South Texas Project
Units 3 and 4
Docket Nos. 52-012 and 52-013
Response to Request for Additional Information

Attached is the response to an NRC staff question included in Request for Additional Information (RAI) letter number 346 related to Combined License Application (COLA) Part 2, Tier 2, Section 6.4. This completes the response to the letter. The attachment addresses the response to the RAI question listed below:

RAI 06.04-3**QUESTION:**

Berm Geometry

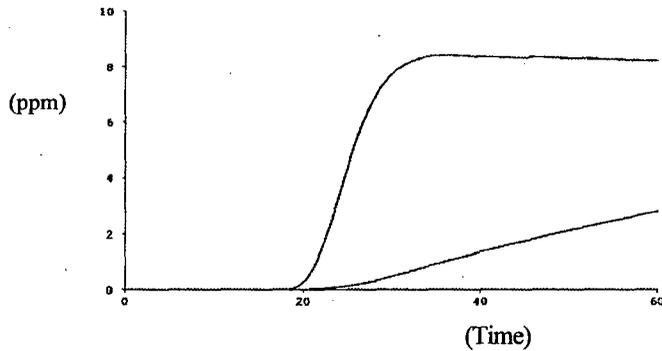
- Justify the maximum puddle size of 100 m radius (31,400 m² area) for Acetic Acid (Offsite Storage) assumed by ALOHA, as no berm geometry or natural topography details are provided that would constrain the puddle size to within a 100 m radius. The staff's confirmatory calculations using HABIT demonstrate that if not confined, the Acetic Acid could spill far beyond 100 m radius and, consequently, lead to a concentration level inside the control room significantly exceeding the IDLH.

Acetic Acid is stored at the OXEA Bay City Plant. Based on information received from the OXEA Bay City Plant, the immediate containment area around this tank has a surface area of 5,422 ft² in area—any larger spills would overflow to a concrete lined channel spillway with a surface area of 3,700 ft². This spillway safely directs the flow to an Emergency Containment Area (ECA) which is a large surface impoundment area with a surface area of 97,782 ft².

- Immediate containment area: 5,422 ft² surface area—which is only a few inches deep, assuming a 2 inch depth, yields a volume of approximately 903 ft³.
- Spillway: 3,700 ft² surface area—10 feet wide, 3 feet deep, and 370 feet in length, yielding a volume of 11,100 ft³.
- Emergency Containment area: 97,782 ft² surface area—6 feet deep, yielding a volume of 586,692 ft³.

Accordingly, when accounting for the total surface area of the containment area for the Acetic Acid tank (i.e., 106,904 ft² or approximately 9,932 m²)—that yields a radius of 56.3 m. This is much less than the 100 m radius (31,400 m² surface area) used as a maximum puddle size in the ALOHA analysis and considered a realistic value for modeling purposes.

Acetic Acid (Offsite Storage) Sixty Minute Concentration Curve—IDLH 50 ppm

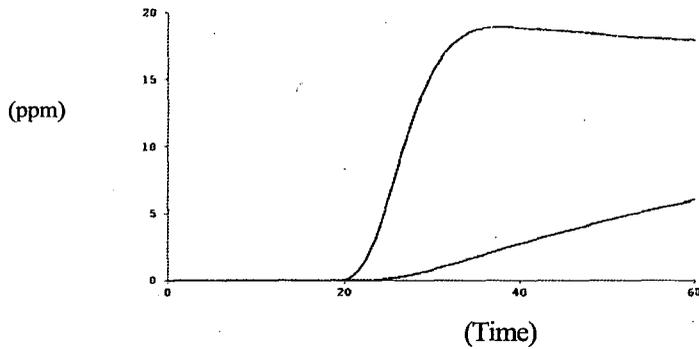
- All toxic gas analysis runs using ALOHA automatically stop at 1hr, while some results show that the control room inside and outside concentrations are still increasing. Complimentary HABIT runs have shown that some control room concentrations can exceed IDLH past the first hour. Demonstrate or justify that the 1-hr analysis cut-off is conservative enough to meet the NRC rules and regulations.

In the five scenarios identified in RAI 06.04-2, in every case the concentration outside the control room was well below the IDLH or identified toxicity limit at the end of the 60-minute run-time in ALOHA and, in all but one case, Sodium Hypochlorite (Onsite Storage), the outdoor concentration had also begun to decline. Even though the inside concentrations are still increasing they would not

become higher than the outside concentrations. This is demonstrated in the ALOHA concentration curves provided below for each of the identified scenarios: Acetic Acid (Offsite Storage), Acetic Acid (Water Transport), Gasoline (Water Transport), 1-Hexene (Offsite Storage), and Sodium Hypochlorite (Onsite Storage).
